Drawing Change Notice

CHANGE DOCUMENT NO.
24590-PTF-VDCN-MS-10-00009

JOB NO.	TITLE FOR CHANGE NOTICE
24590	UFP-VSL-00062C Redesign

Based on the re-analysis of UFP-VSL-00062C, per calculation 24590-PTF-MVC-UFP-00023, for revised seismic conditions and design evolution, required a redesign of the vessel.

SAMPLER PUMP RFD DETAIL
SCALE: 1/10

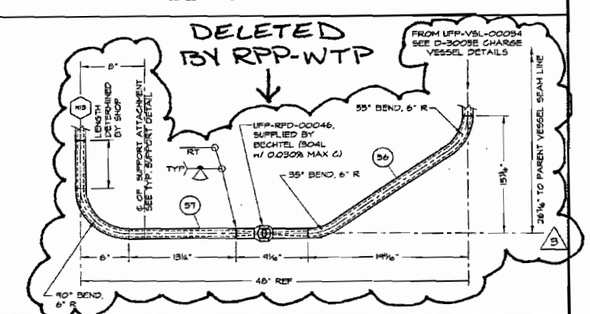
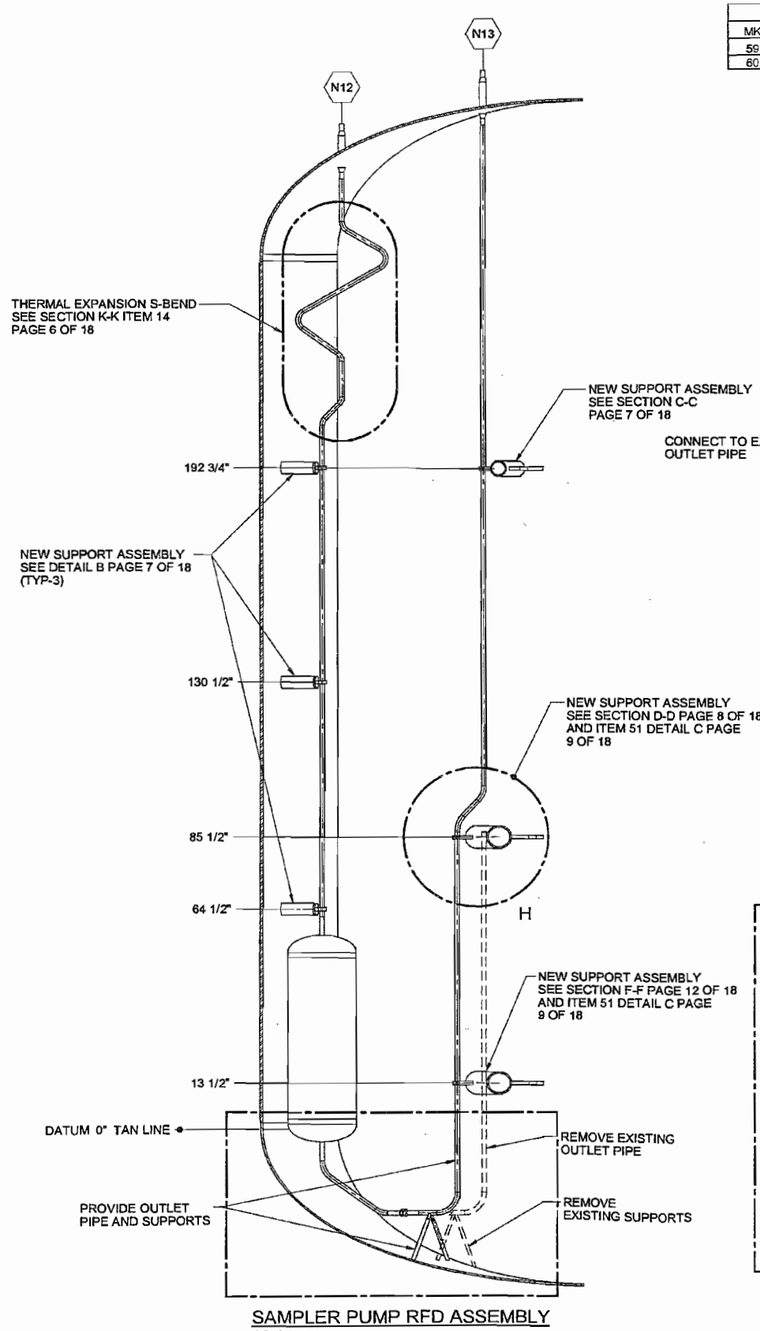
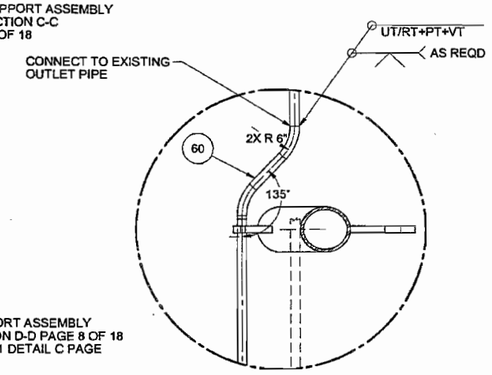
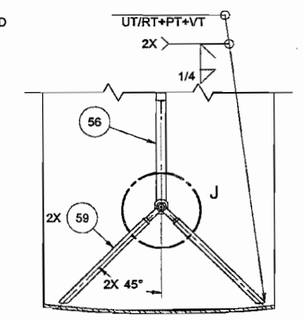
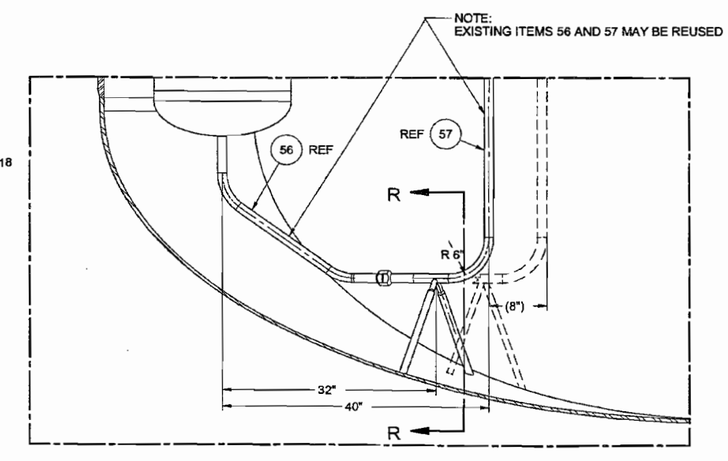
c.) Sampler RFD Pump Detail:

(1.) Remove support item 58 from TYP SUPPORT DETAIL.

(2.) Add DETAIL J, SECTION R-R, and SAMPLER PUMP RFD DETAIL shown on Attachment 1, page 16 of this VDCN.

(3.) Delete other detail shown and replace with SAMPLER PUMP RFD DETAIL and DETAIL H shown on Attachment 1, page 16 of this VDCN.

REMOVE BY RPP-WTP

DELETED BY RPP-WTP

2" SCH 80 INLET TO INTERNALS
SCALE: ¾" = 1"
~~N34~~ N35 N36

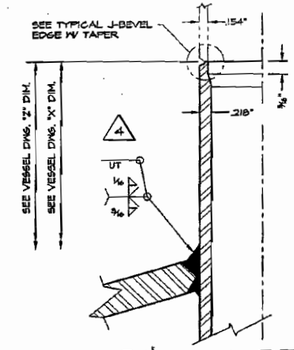
a.) 2"SCH 80 INLET TO INTERNALS: Delete N34 and replace with Typical SCH 160 Nozzle Detail (REF Section Q-Q, Attachment 1, page 6 of 18).

DELETE N34 AND REPLACE WITH TYPICAL SCH160 NOZZLE DETAIL (REF SECTION Q-Q) BY RPP-WTP

A WASH RING TEE
SCALE: 1/4" = 1"

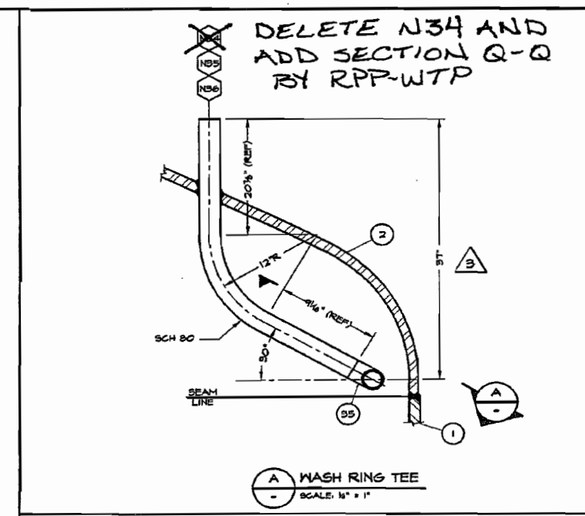
a.) WASH RING TEE: Delete N34 and add Section Q-Q which depicts N34 details show on Attachment 1, page 6 of this VDCN.
